ITEM: 6.14	REPORT SUMMARY MINOR VARIANCE APPLICATION FILE NUMBER A209/23
-------------------	--

MINOR VARIANCE APPLICATION FILE NUMBER A209/23

CITY WARD #:	4
APPLICANT:	VMC GP Inc.
AGENT:	Vanessa Bulfon, Lauren Capilongo, Angela Fang
PROPERTY:	3201 Hwy 7, Vaughan
ZONING DESIGNATION:	See below.
VAUGHAN OFFICIAL PLAN (2010) DESIGNATION:	Vaughan Official Plan 2010 (,VOP 2010'): "Station Precinct", Volume 2, Vaughan Metropolitan Centre ('VMC') Secondary Plan
RELATED DEVELOPMENT APPLICATIONS:	DA.17.015.
PROPOSAL:	Relief from the Zoning By-law is being requested to facilitate the redevelopment of the subject lands for a high-rise, mixed-use development consisting of residential, retail, office, and privately-owned publicly accessible space uses. Relief is also required to facilitate related Site Development Application DA.17.015.

MIXED USE DEVELOPMENT AT HIGHWAY 7 AND INTERCHANGE WAY (VAUGHAN, ON)

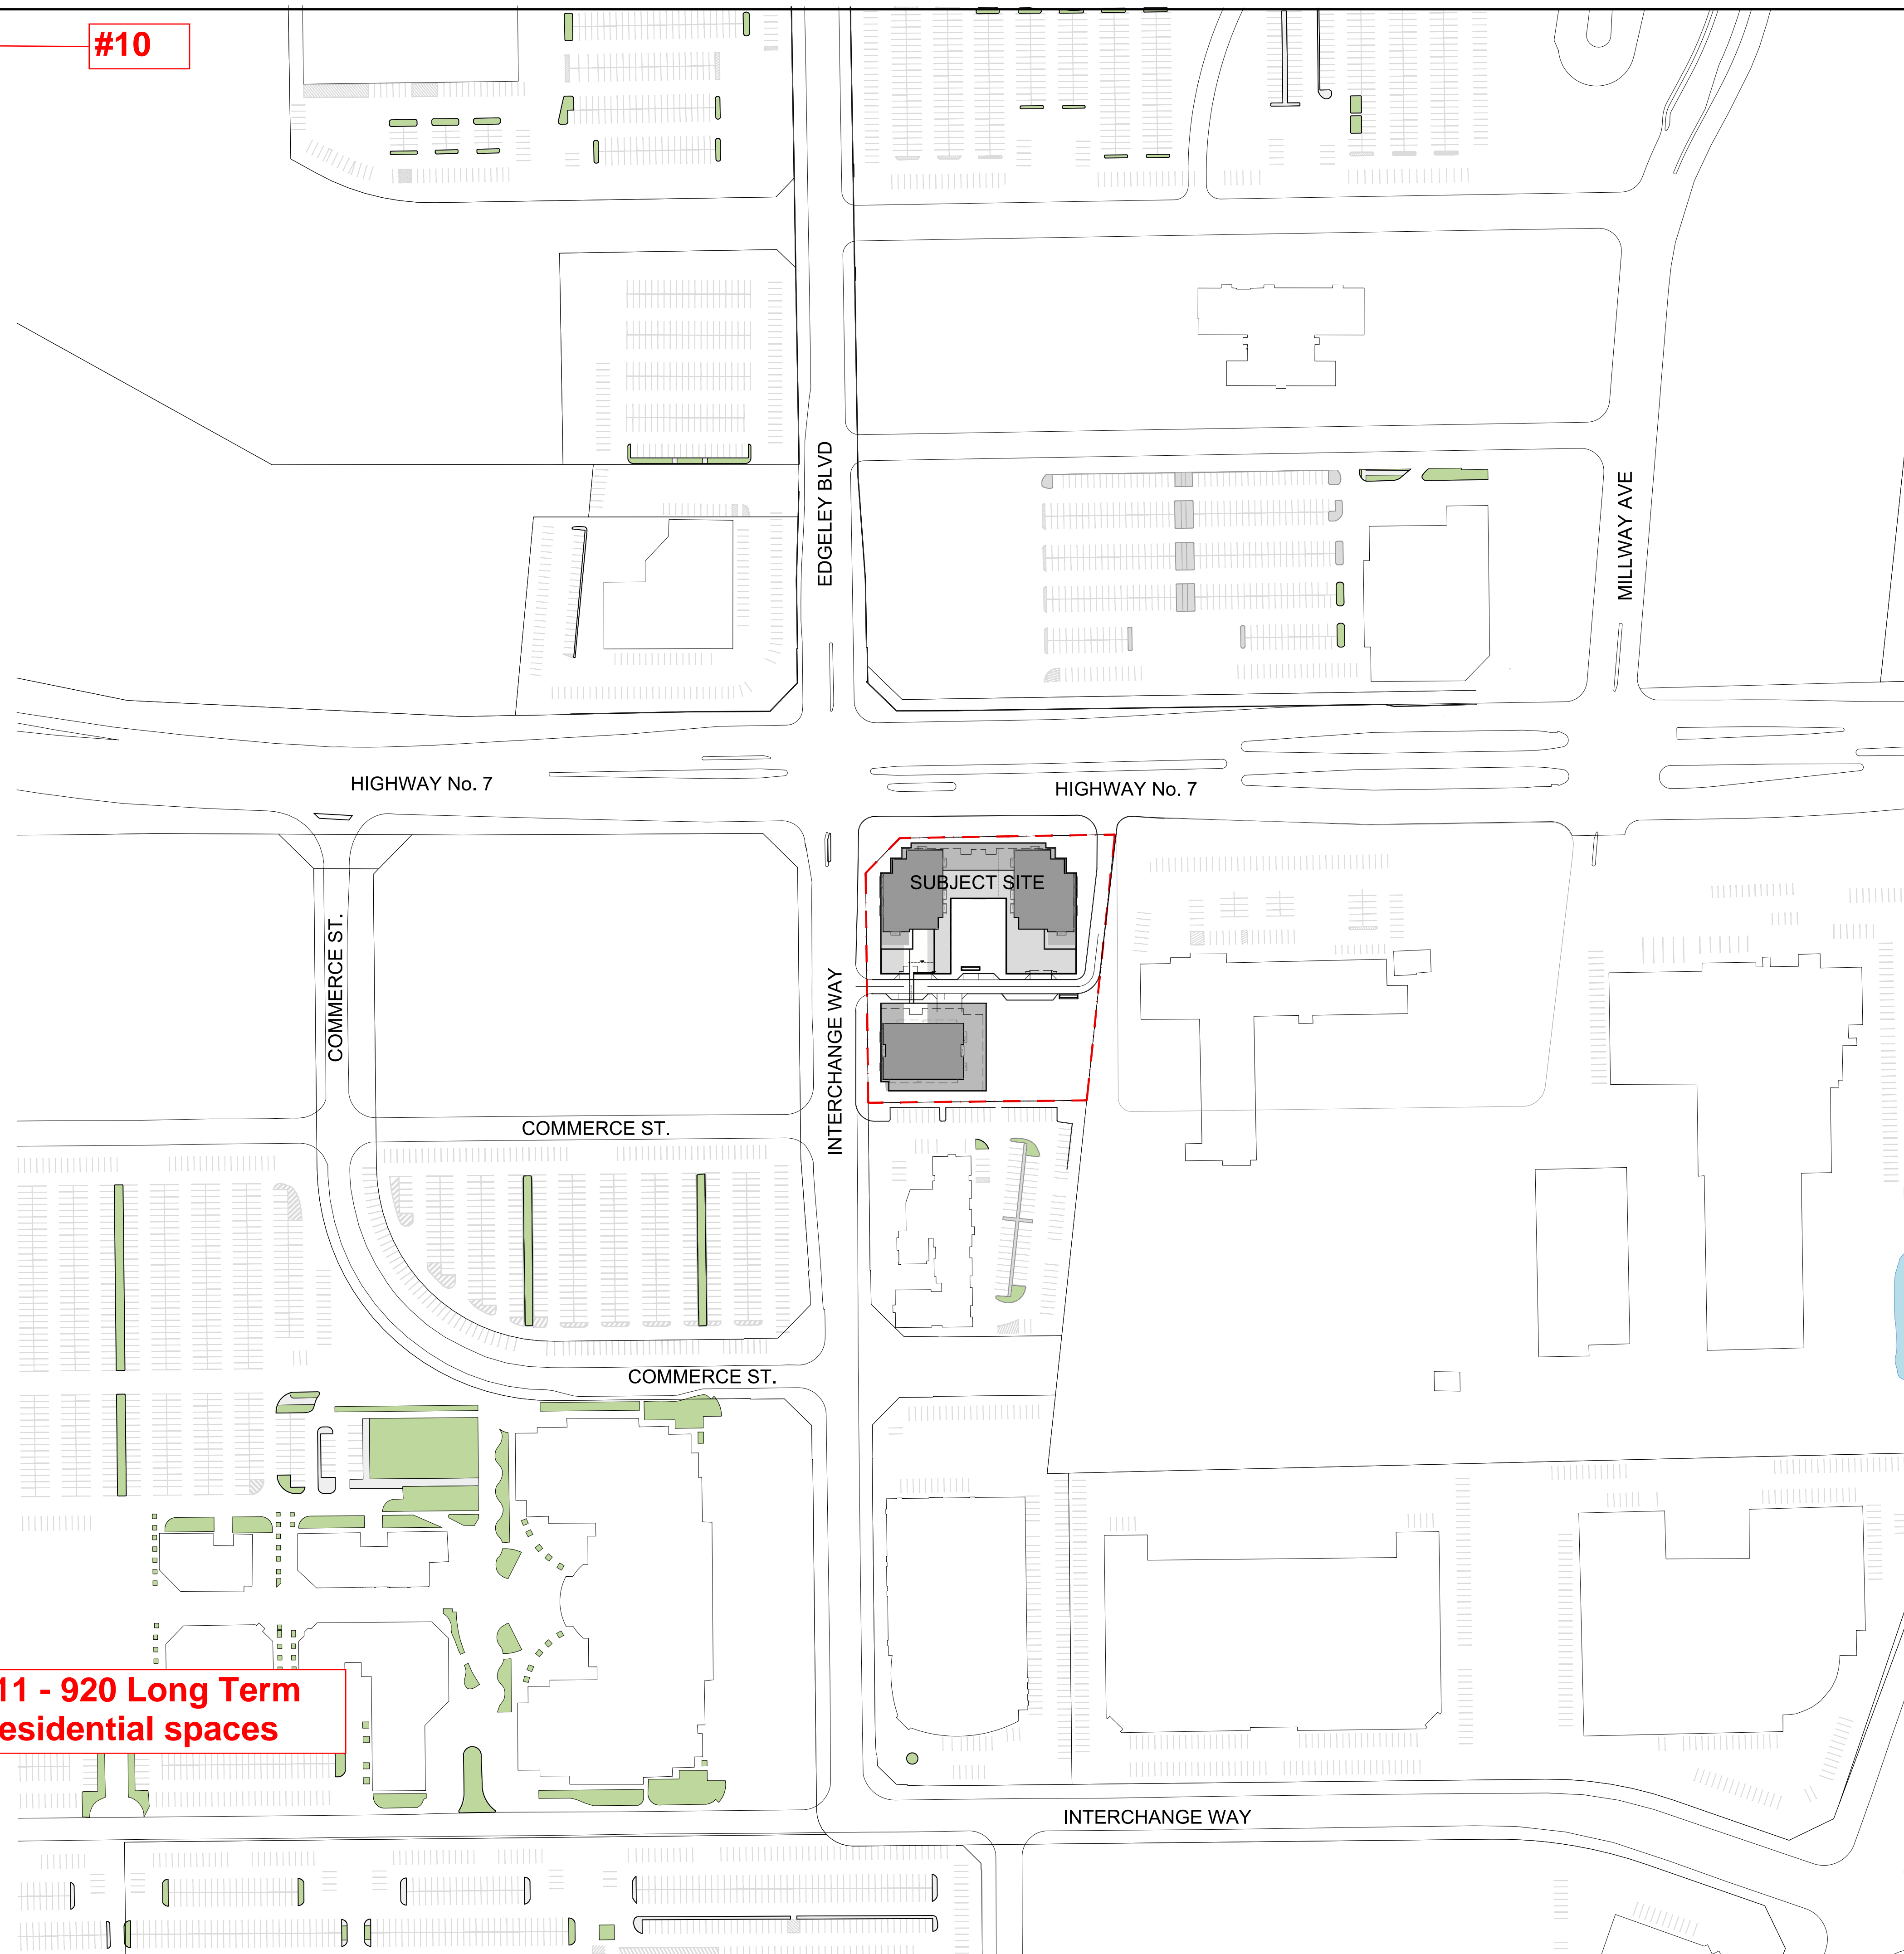
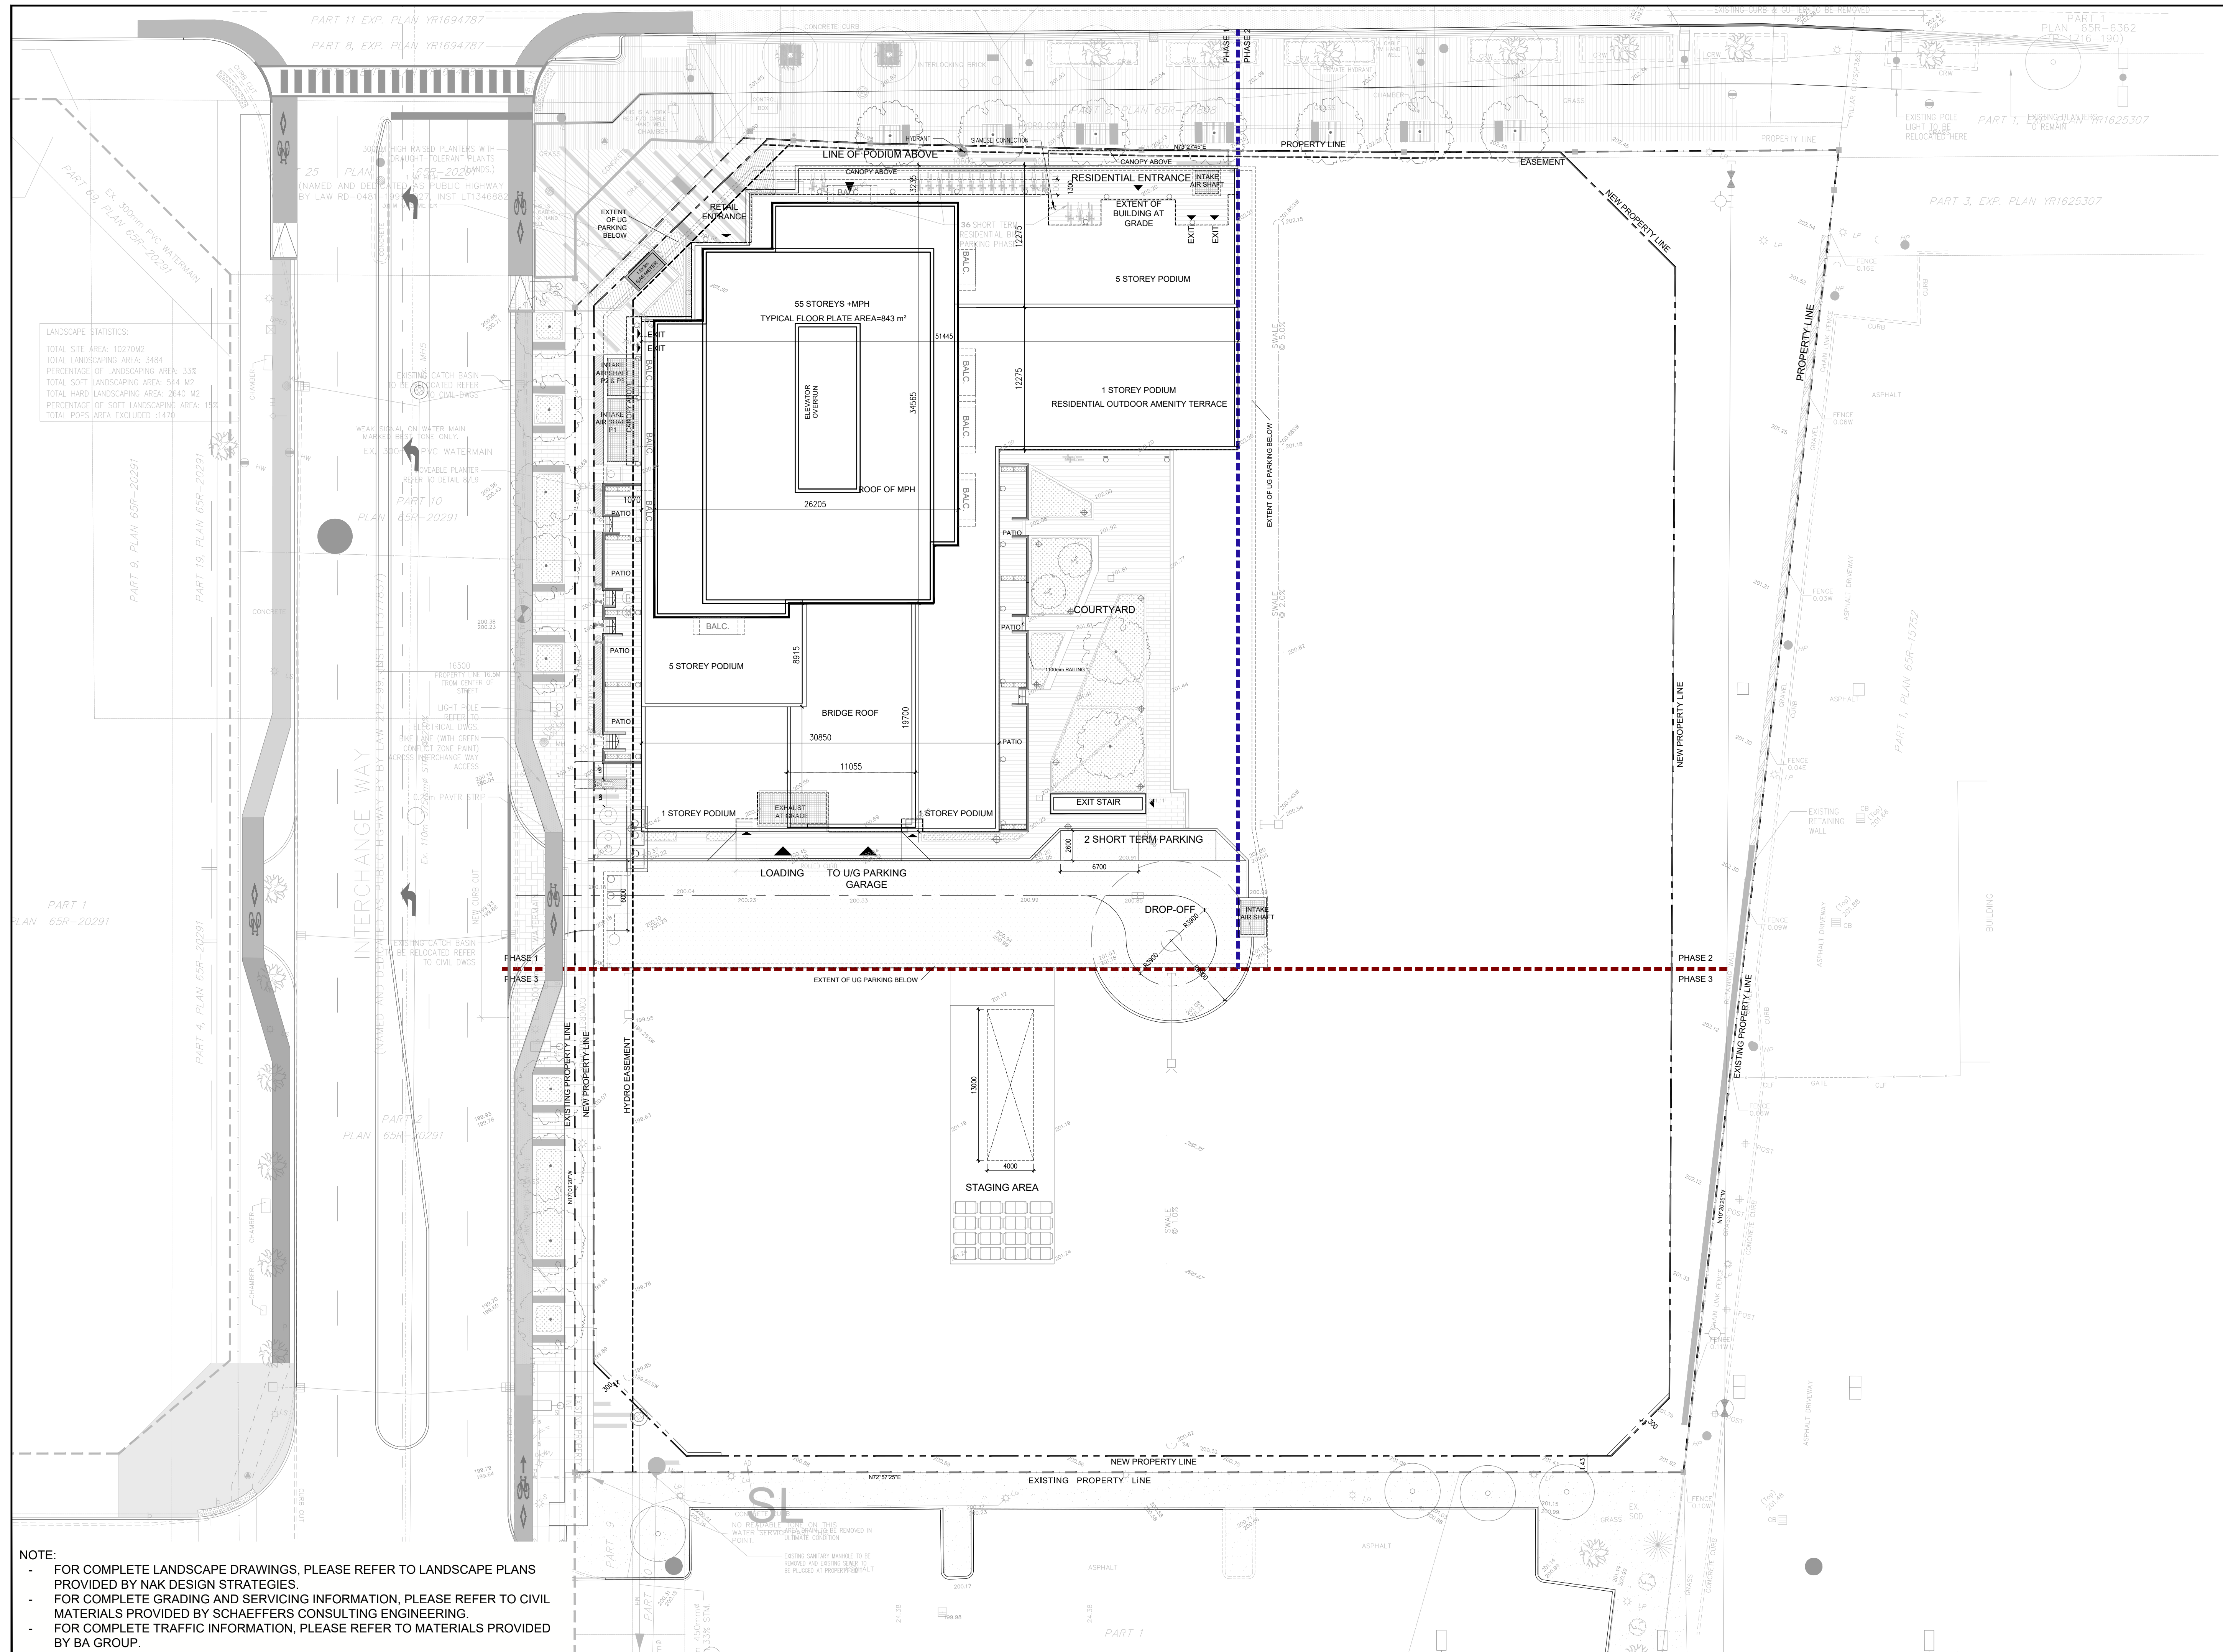
#10

#11 - 920 Long Term Residential spaces

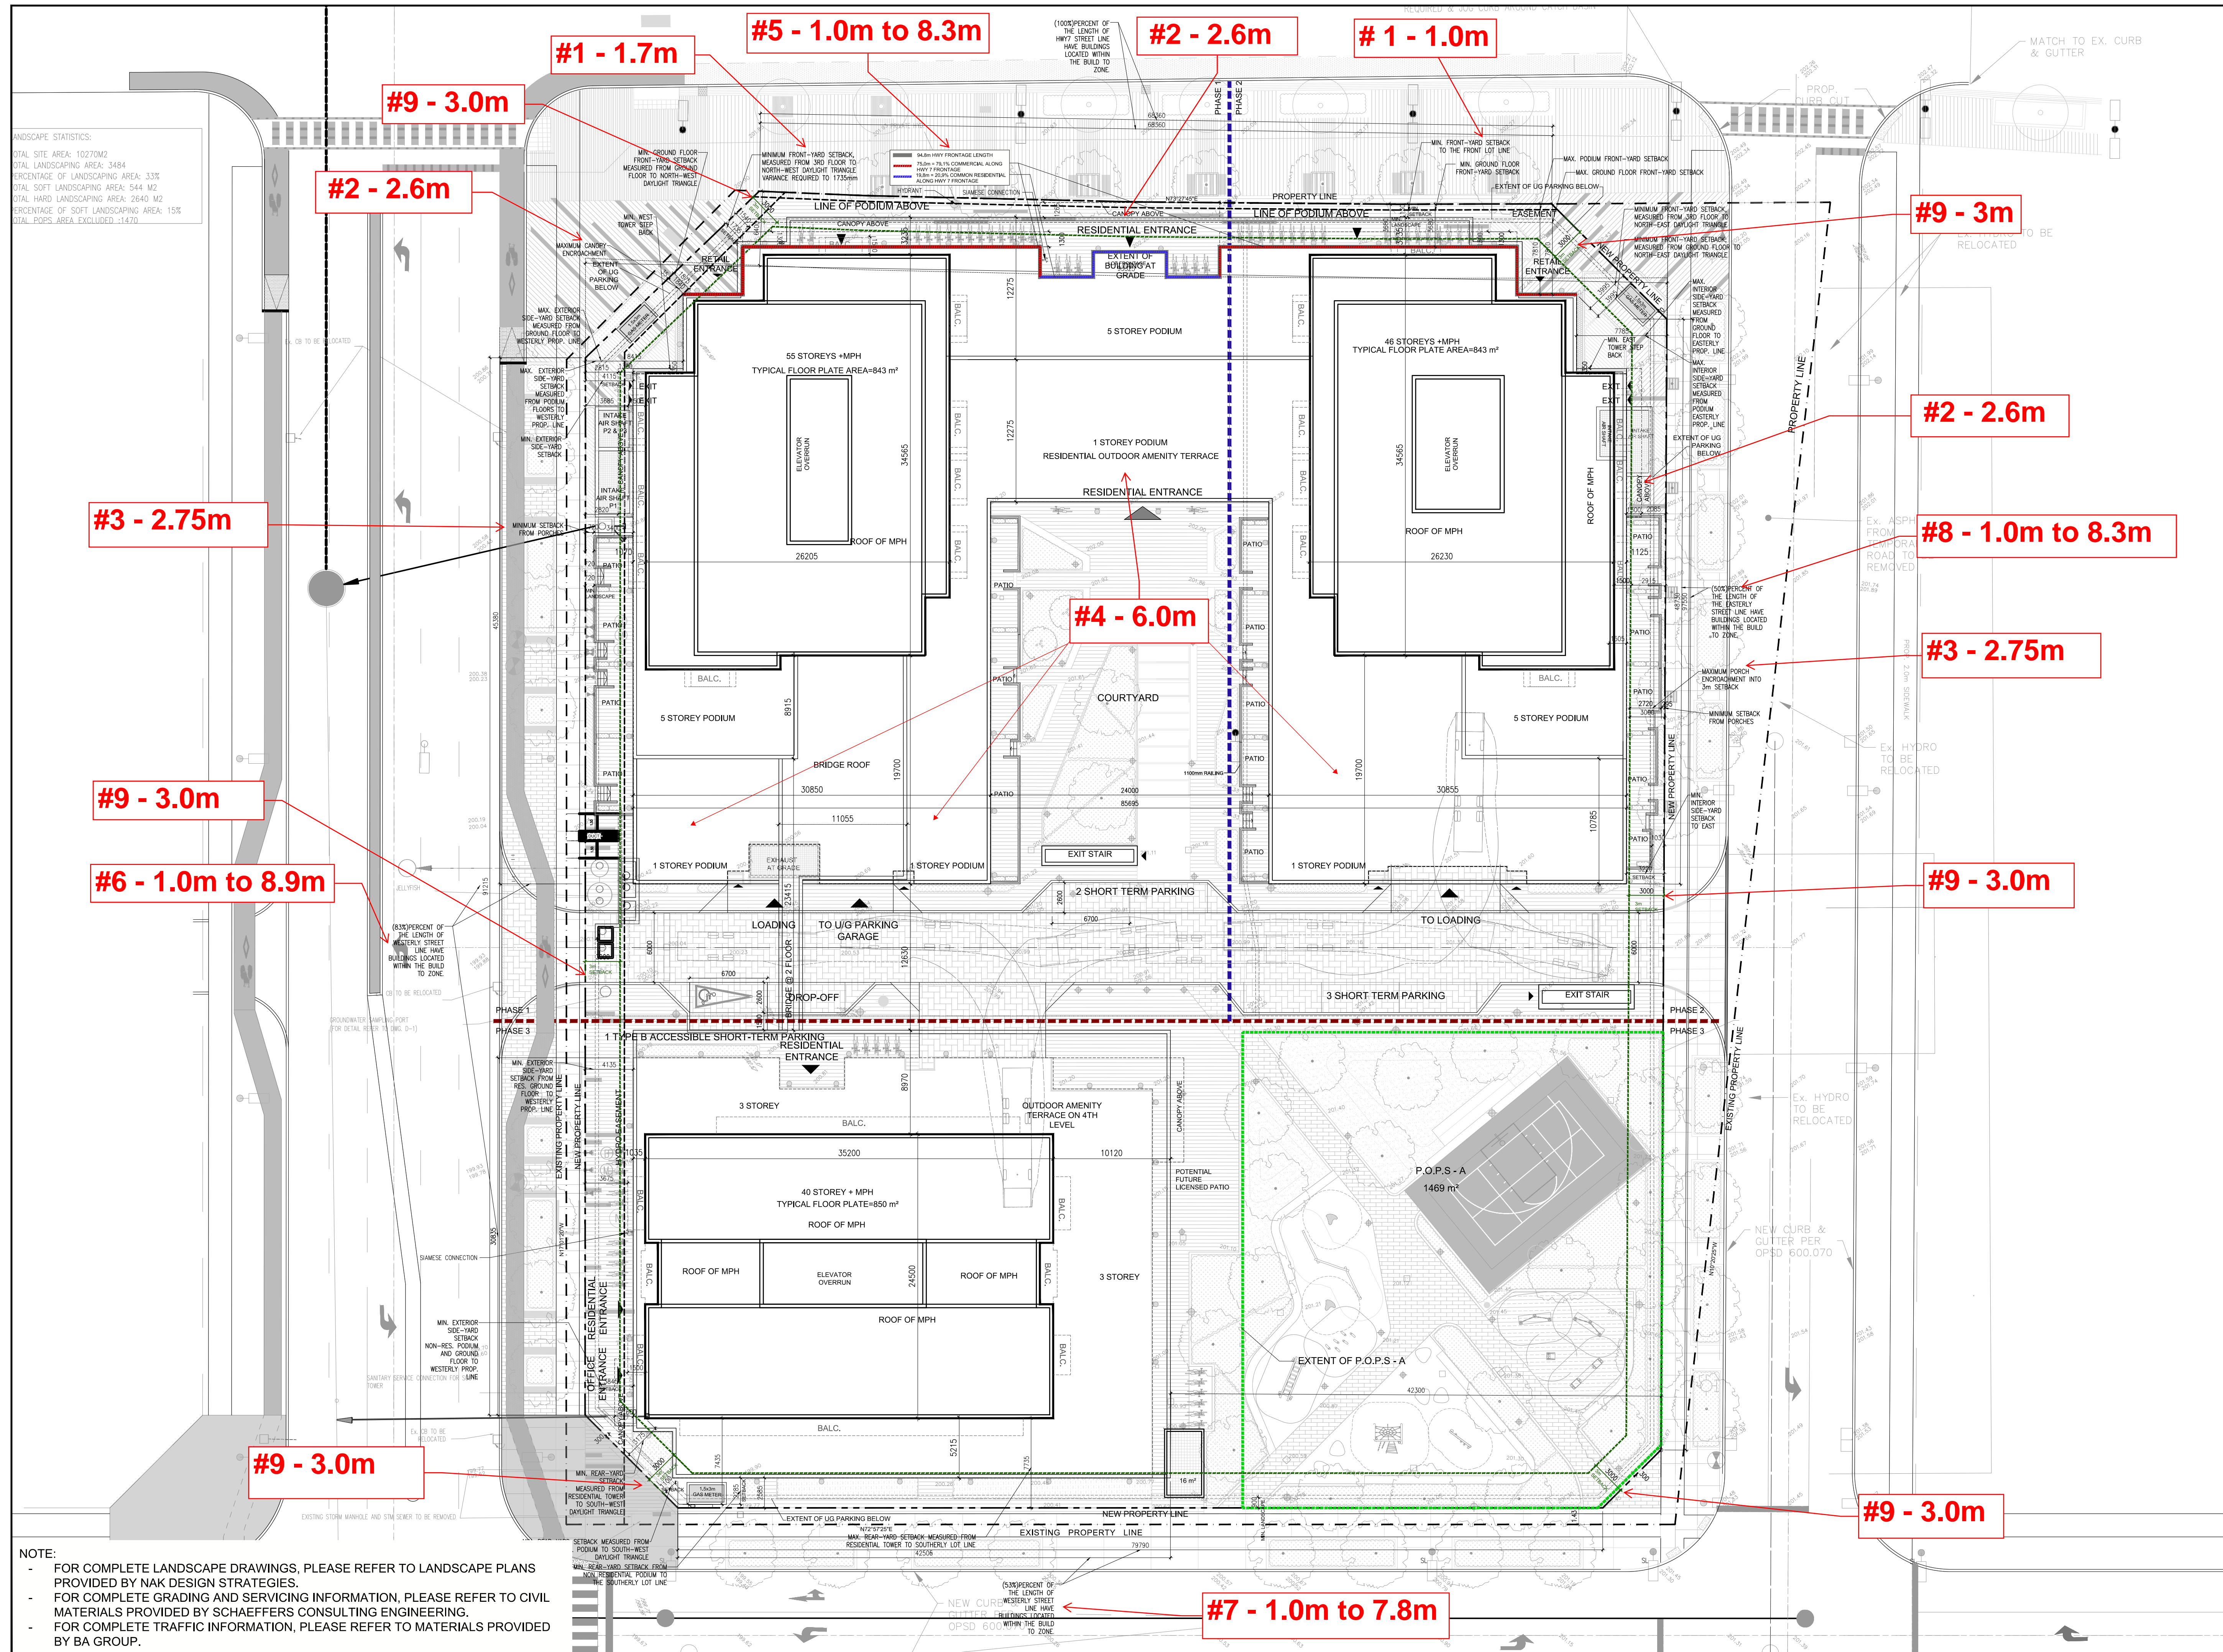
General Comments	
1	The applicant shall be advised that additional variances may be required upon review of detailed drawing for building permit/site plan approval.
2	The attached sketch referenced in variance 10, shall be the Site Plan Ultimate A.100D as submitted in the minor variance application.
